Subject: Artificial Turf Feasibility for 6059 77th Ave SW, Mercer Island, WA

PROJECT TITLE  
**PEYREE RESIDENCE**  
6059 77TH AVE SE  
Mercer Island, WA 98040

DRAWING TITLE  
**LAYOUT, MATERIALS, GRADING, & UTILITIES PLAN**

L0.2

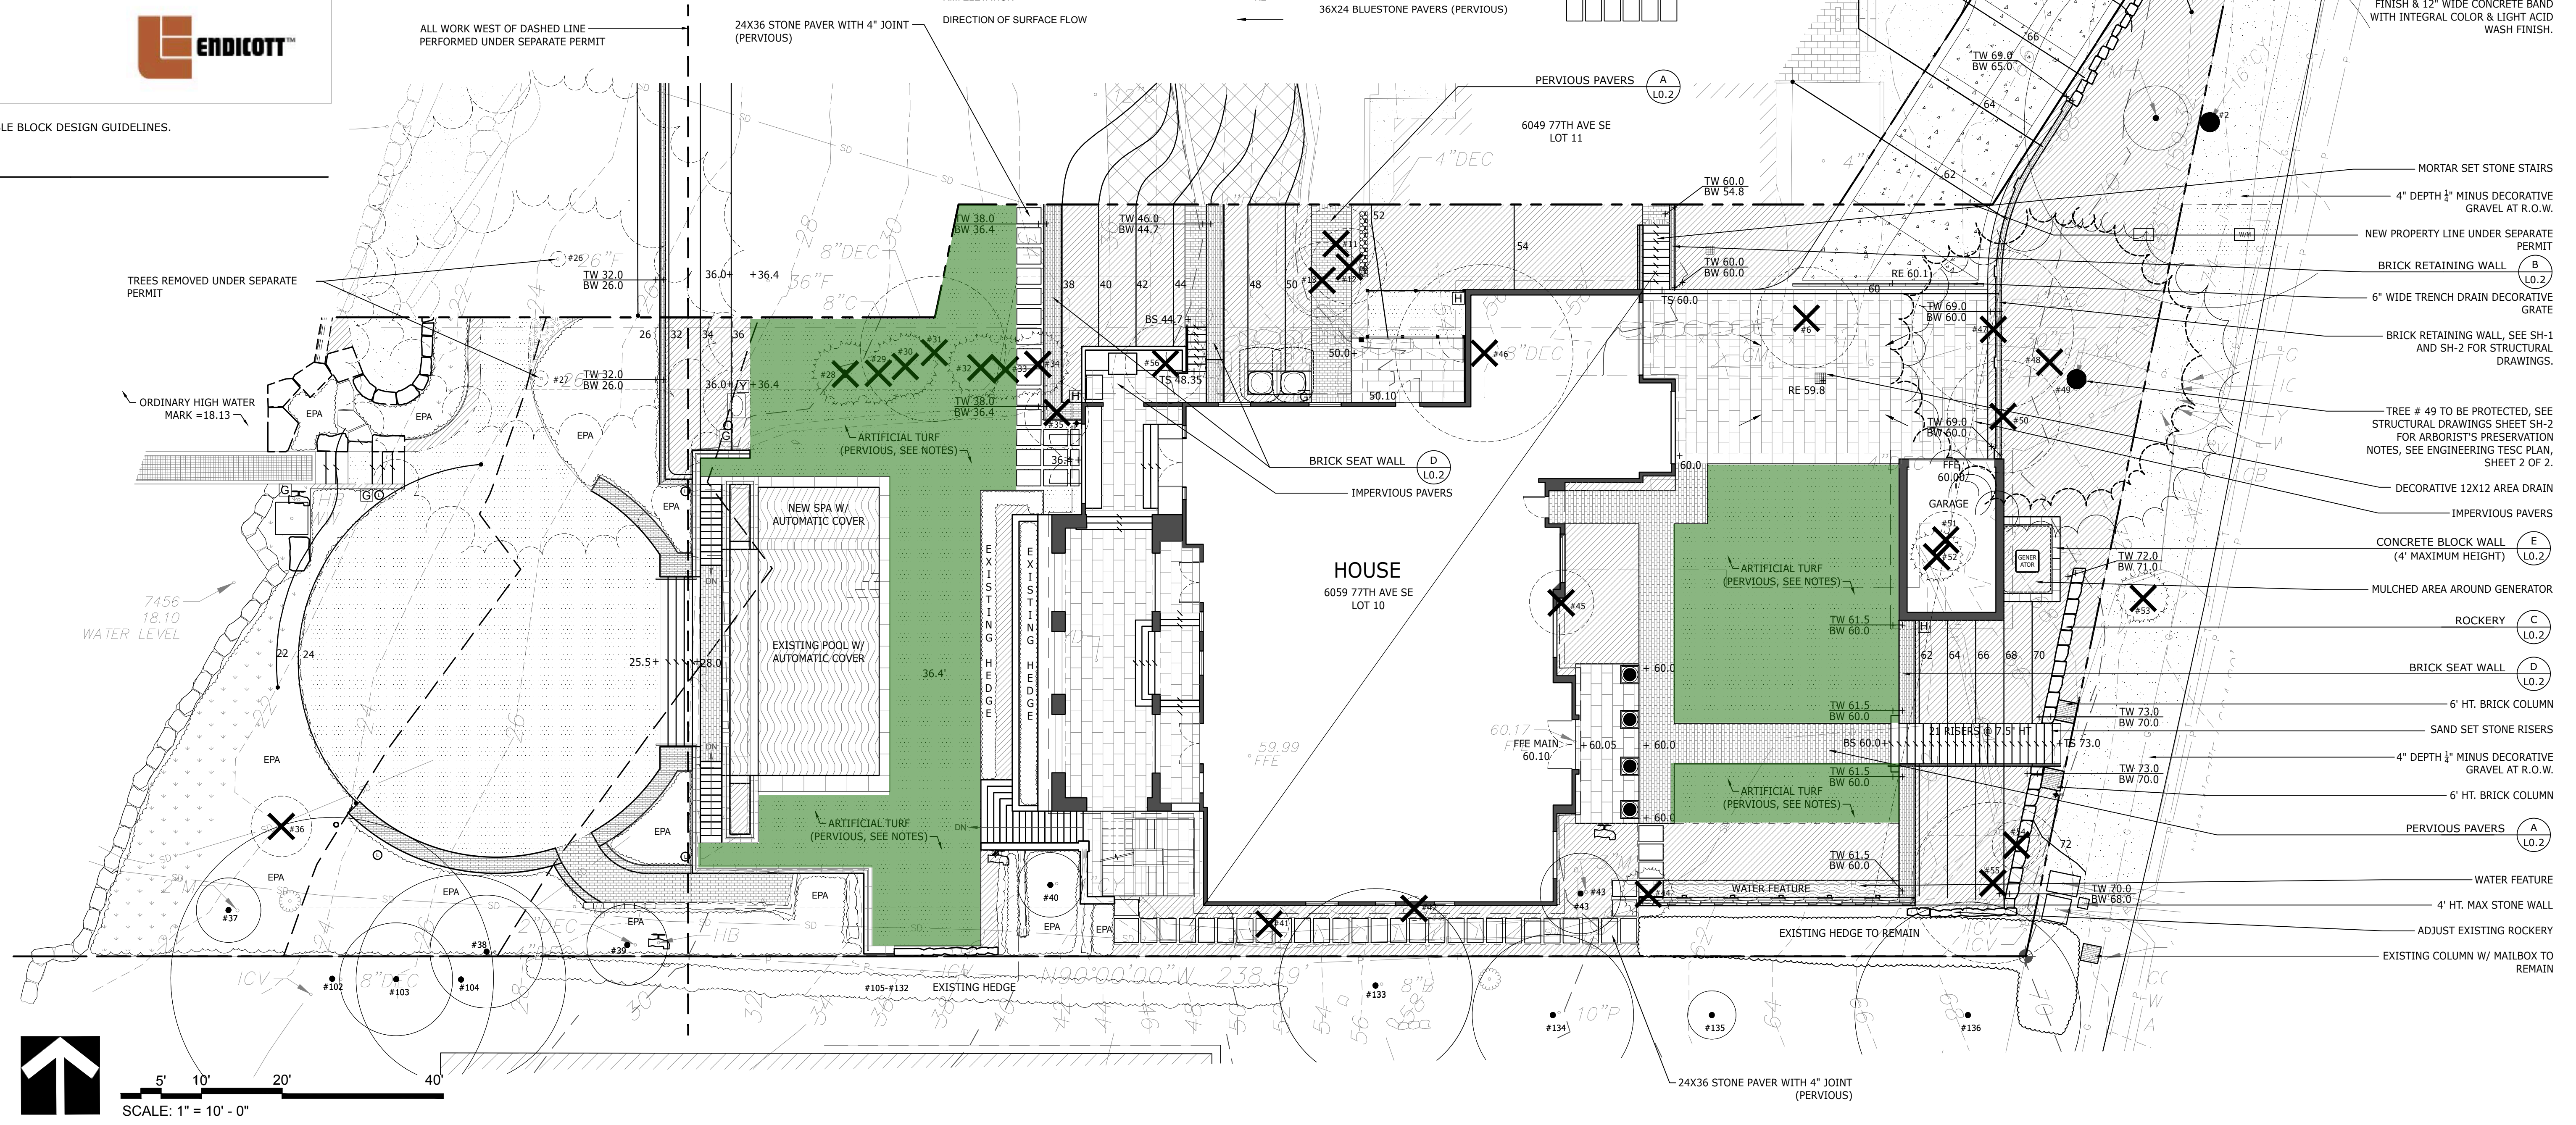
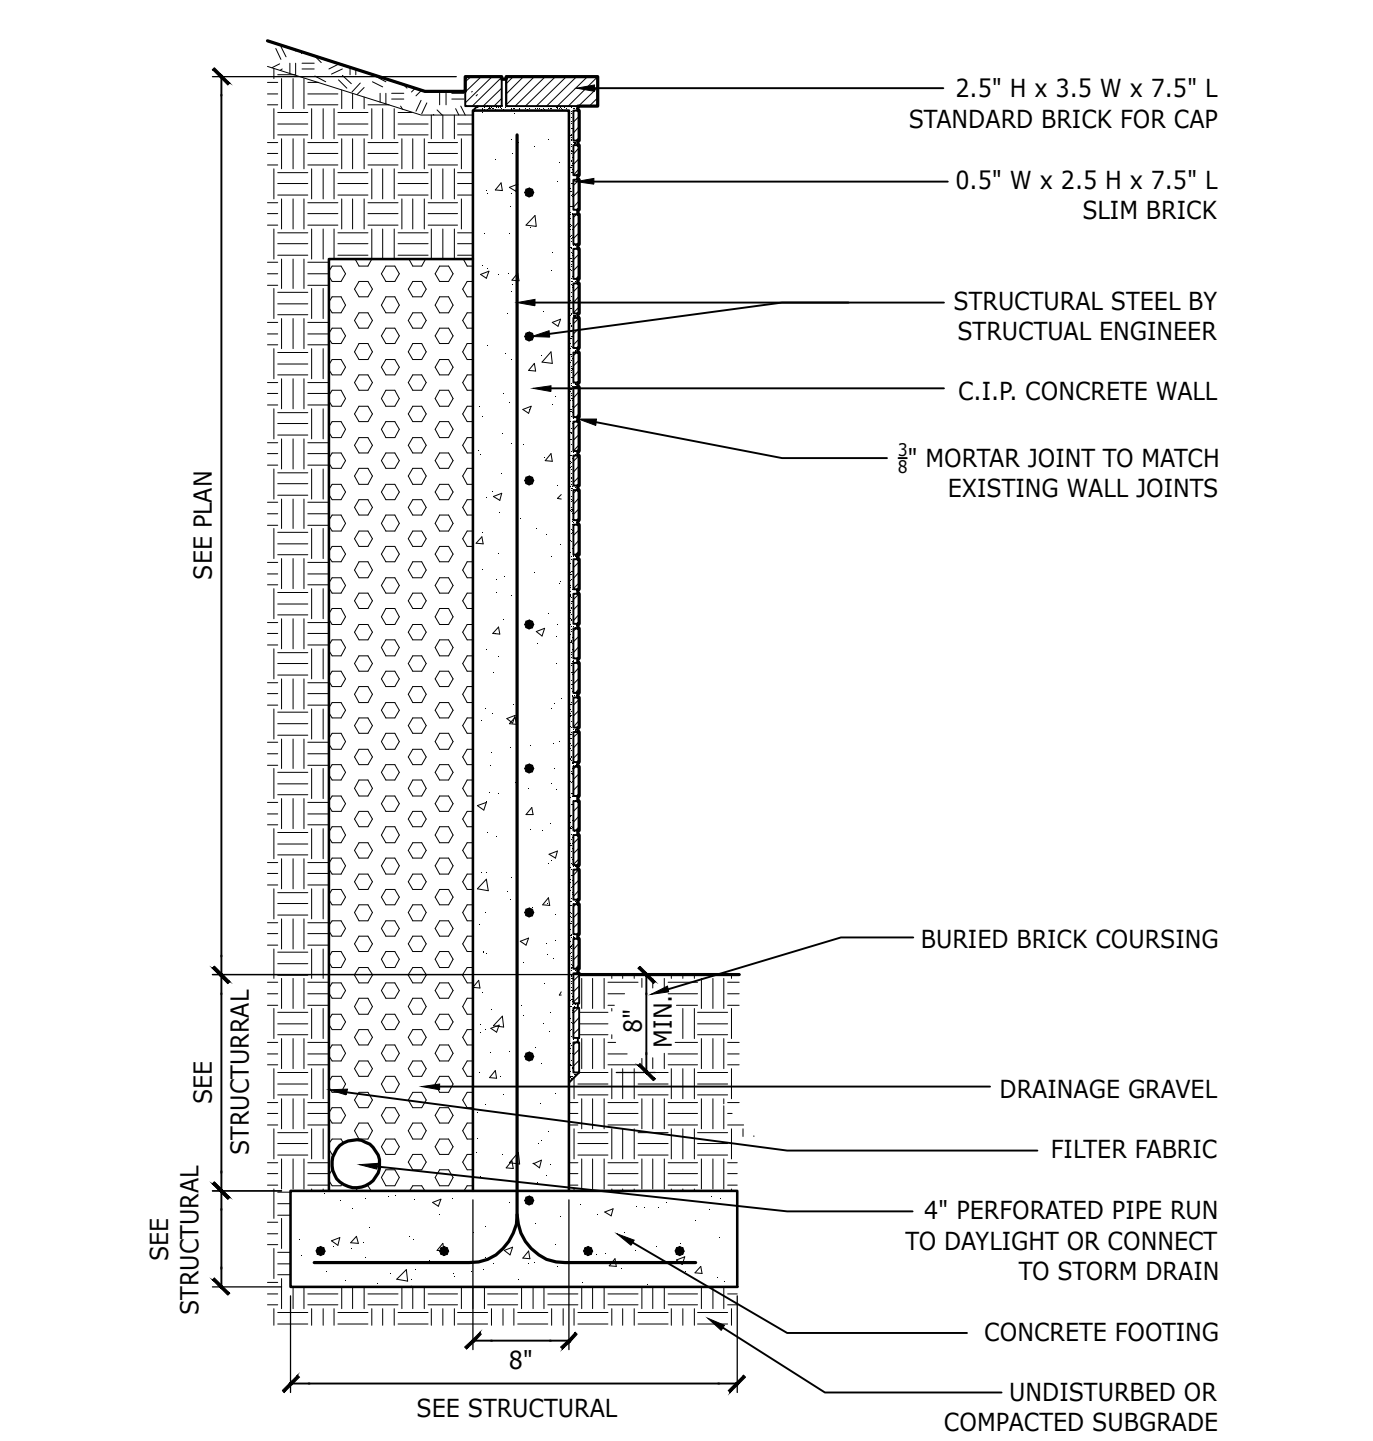
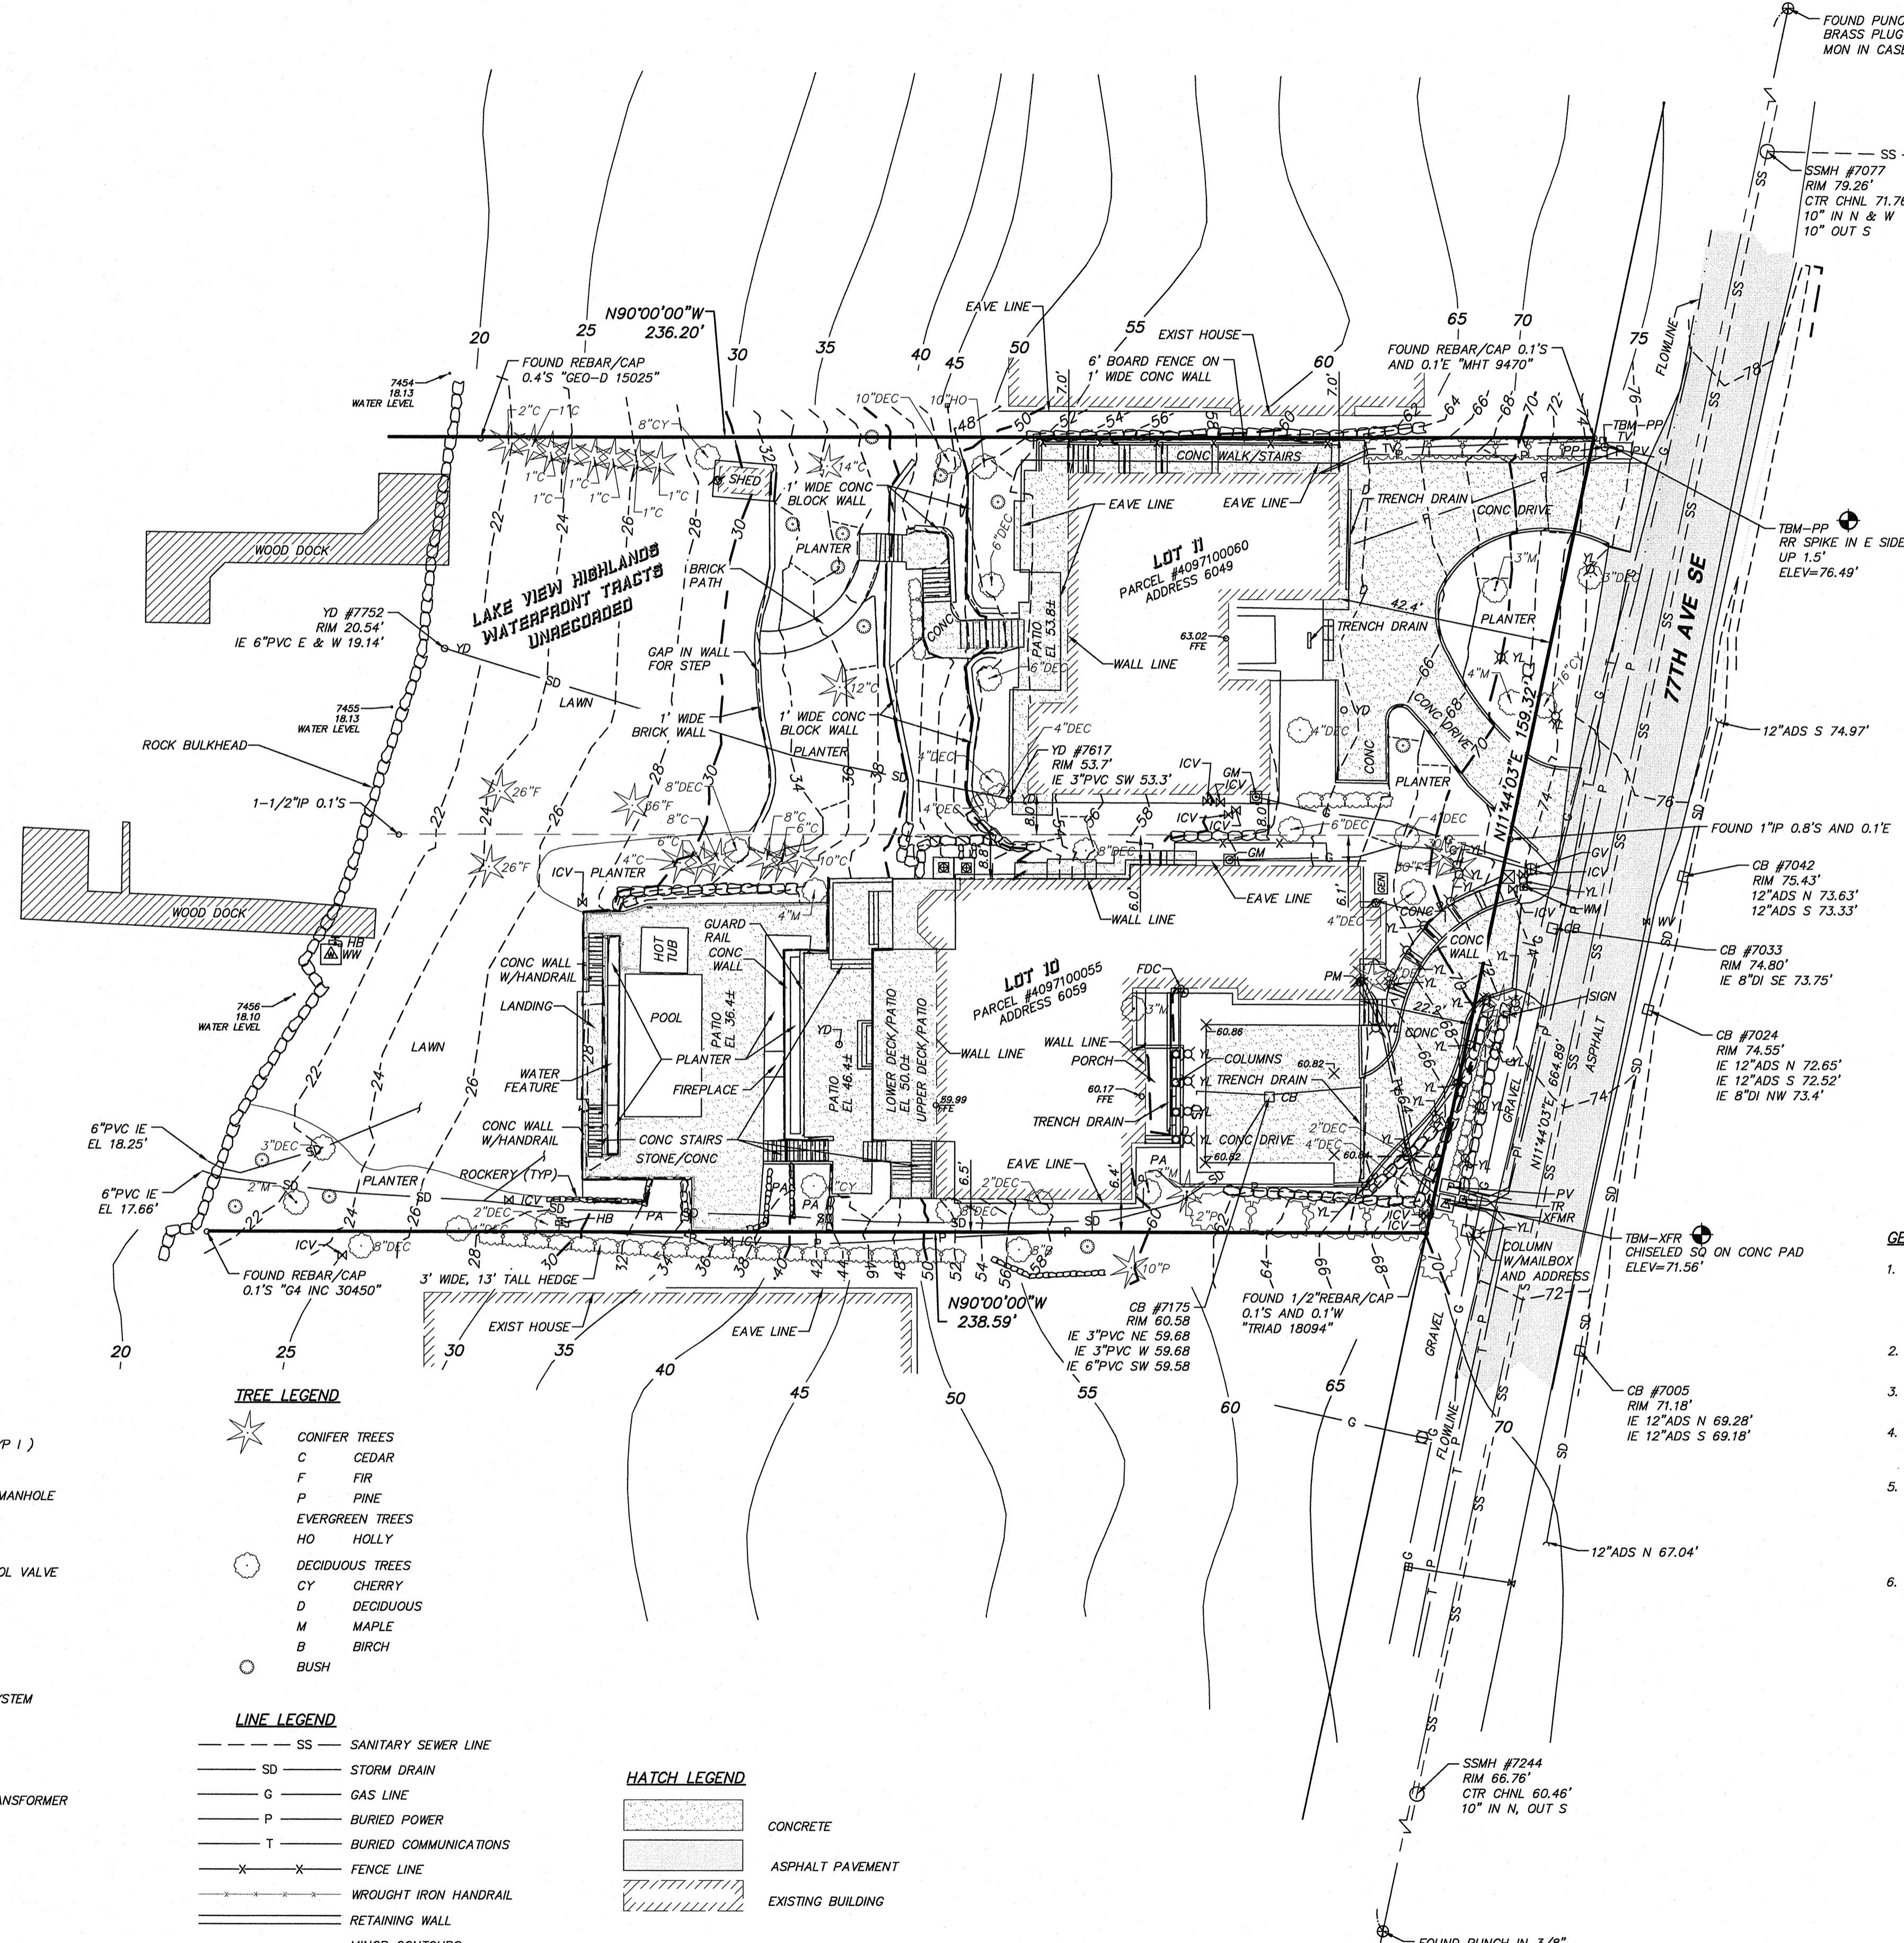
I have a project, currently under construction, in which we are considering replacing the lawn that is shown on the permit for a pervious artificial turf. No lawn has been installed yet as the project is in the early phases of construction. Our understanding of the code allows us to make this change. The project is vested under current code per building permit # 1706-084.

There are two turf areas that we are considering: the Eastern Turf Area and the Western Turf Area. The Eastern Turf Area is proposed to be placed where an impervious driveway, impervious autocourt, and impervious garage originally existed. The Western Turf Area is proposed to be placed where an impervious stone patio originally existed. The soils underneath these surfaces was evaluated by geotechnical engineers. Please see attached L0.2 Landscape Plan with turf area indicated in green. Please see Topographic Survey by Triad.

ARTIFICIAL TURF

- 1. TEST PITS TO BE DUG ON SITE TO ENSURE SOIL DRAINAGE FOR ARTIFICIAL TURF
- 2. ARTIFICIAL TURF TO BE SITE TESTED TO VERIFY DRAINAGE CAPACITY.

Based on the code MICC 19.16.010.I.Impervious.6 and the supporting documents the proposed development does not retard water from reaching the soil mantle, and is not considered impervious per MICC 19.16.010.I.Impervious.6. The artificial turf will not only equal the existing condition, but creates an improved condition for water to enter the soil mantle. I am requesting your approval for this change. Please let me know if there is any other documentation that you may need to further understand our request or if you have any other comments or questions.
